PCN - 20 064

Product Name:	Minitek 3.0 Header High Curent			
	Right Angle Header			
Product Manager:	Jithin George			
Subject:	Notification of Planned Change			
Distribution:	Affected Customers			
Type of Change:	Documentation Change			
Change Description:	Updating Customer drawings			
Reason for Change:	Customer drawings are being updated to match print dimensions to the actual product supplied. Missing Dimensions are added, AU prefix to part number option added and Packing note added			
Affected Parts:	See Attached Affected Parts.xls			
Effective Date of Change:	September 10, 2020			
Last Time Buy Date:	NA			
Last Disty Return Date:	NA			
Last Time Shipment Date	NA			
Datasheet Attached?	No			
Qual/Test Data Attached?	No			
Samples Availability Date:	August	31	2020	
Available Alternatives?	Select			
Questions?	<i>Contact your local AFCl Representative, or Product Manager</i>			
	<i>Jithin George</i>			
	<i>+91 (484) 3391945 / Jithin.George@fci.com</i>

Product: Minitek PWR3.0 RA HDR HCC 10132449

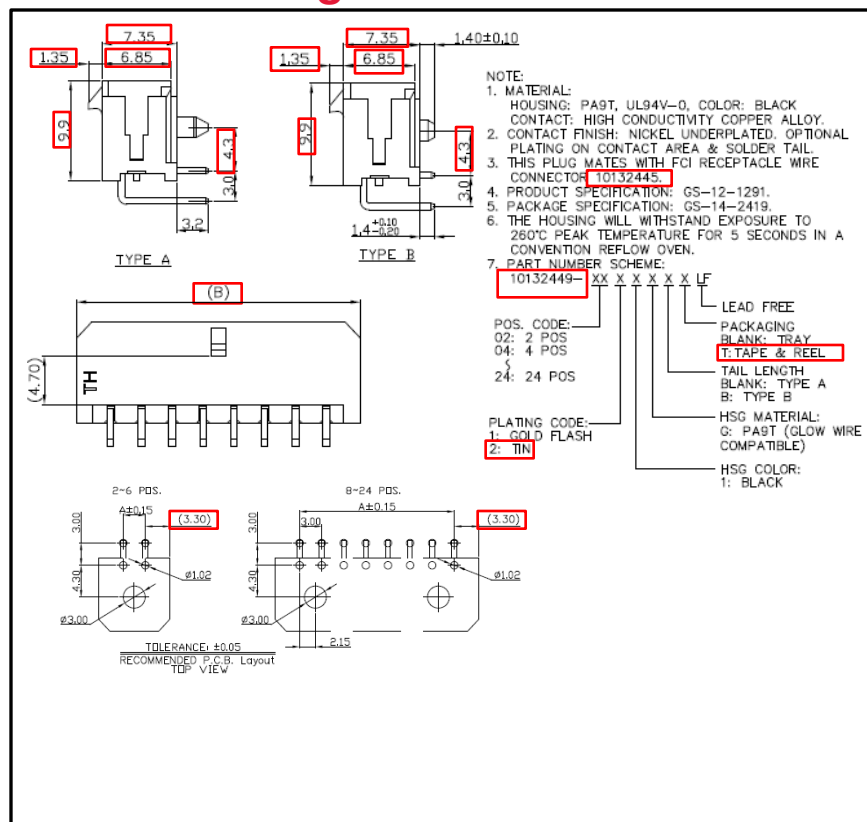
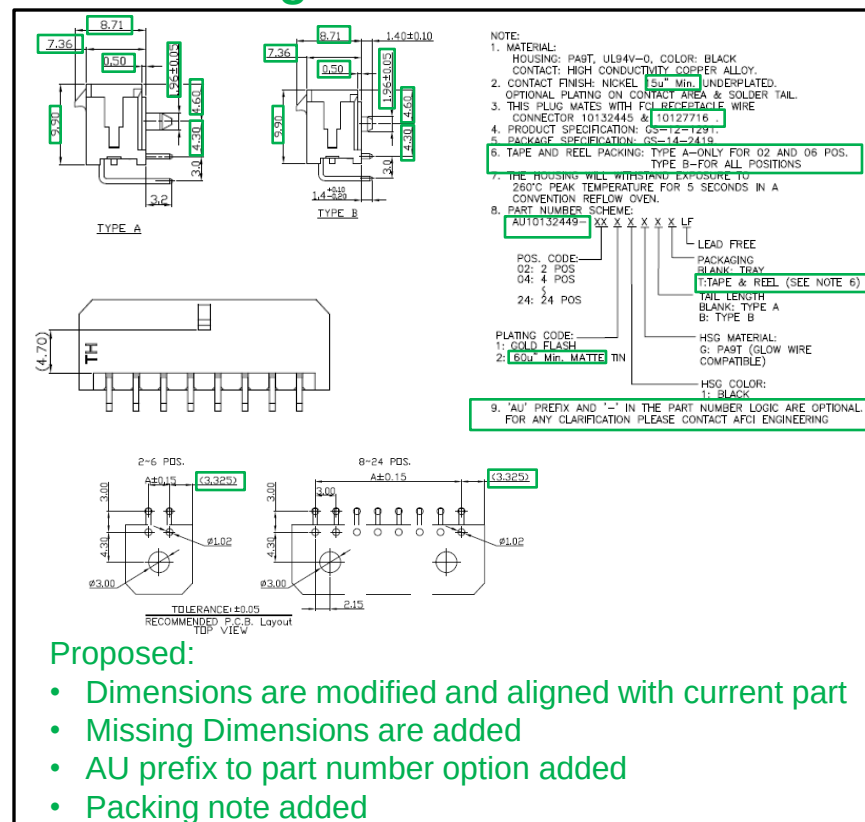
- Dimensions are modified and aligned with current part
- Missing Dimensions are added
- AU prefix to part number option added
- Packing note added

Description of Change: ➤ Drawing Updation of the listed part numbers to have correct correlation of prints and the actual product.
